**Our Case Number:** ABP-314724-22

**Re:** Railway (Metrolink - Estuary to Charlemont via Dublin Airport) Order [2022]  
Metrolink. Estuary through Swords, Dublin Airport, Ballymun, Glasnevin and City Centre to  
Charlemont, Co. Dublin

**Shandon Residents Association submission — Metrolink RO case number 314724**

Briefing note on issues at Glasnevin Station  
(Coke Oven Cottages, Shandon Mill, Royal Canal Cleanup Group & PVTT)

LLCA18  
VVM18.1 Proposed - No  
BusConnects

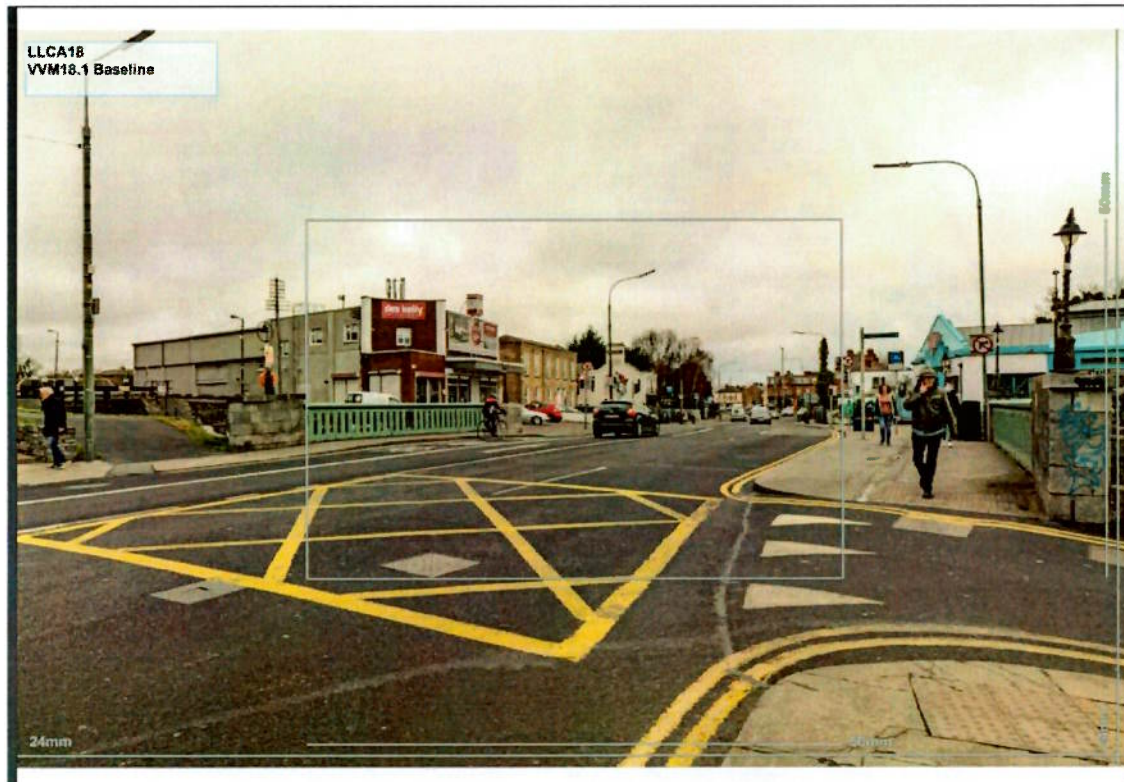
The updated photomontages ([Day 21, item 15](#)) and original photomontages ([Appendix A 27.1 to EIAR](#)) for Glasnevin don't show any discernible differences between the montage showing the SE corner of the station (page 192 of A27.1 and page 123 of the updated photomontages despite the changes to the layout and details shown on the amended drawing .

None of the images included in the Additional OH Information is helpful at showing the planting proposals; we can only get a vague impression of boxes and benches from the

views from the east and north (pages 194 and 196 in the original proposal and 126 and 128 in the updated version) – again differences between the versions are very difficult to spot.

It is difficult to discern the tow path access from the renderings as the camera angle is unhelpful.

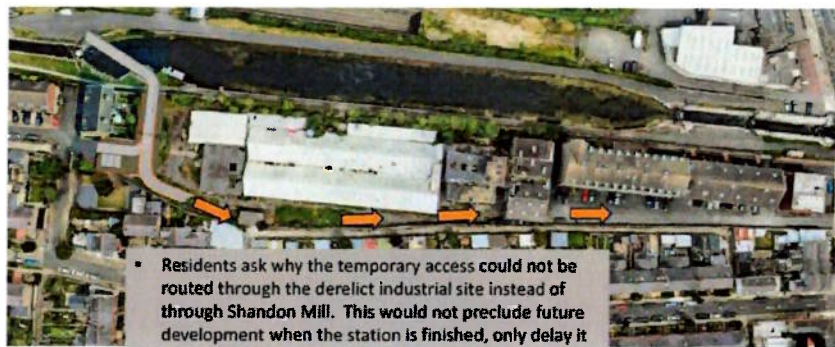
Coke Oven Cottages (COC) is a row of cottages about 800m NW of Phibsborough Road along the Royal Canal Way (RCW) [Image 1].

RCW is the only vehicular access to these properties which rely on deliveries of bottled gas and other fuel and tankers to pump out septic tanks. It is also the only vehicular access for emergency vehicles.

Whilst residents have car parking in their driveways, there is an 800m long walk to get to the nearest bus stop. COC residents (some of whom are elderly and/or have mobility problems) have a long-standing agreement with Jerry Kelly's Carpet store to use the parking spaces in front of the store [Images 2 and 3] – this will cease to be available when the construction of Glasnevin Station commences.

Proposed arrangement where RCW meets Phibsborough Road

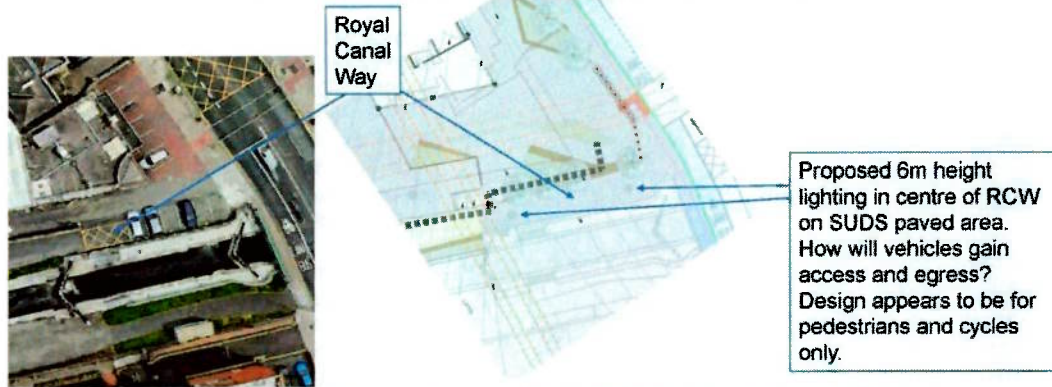
- **Permanent access arrangements for Coke Oven Cottages during the operational period:**
  - Request for clarification of proposed route for vehicles where Royal Canal Way (RCW) meets Phibsborough Road (possible error on RO structures drawing appearing to show RCW as insufficiently wide and pedestrian only across station concourse)

- Ensuring safe width for residents' cars, service and emergency vehicles along RCW in the reinstated stretch, especially where it passes along the canal bank.

Permanent access arrangements for Coke Oven Cottages during the operational period:
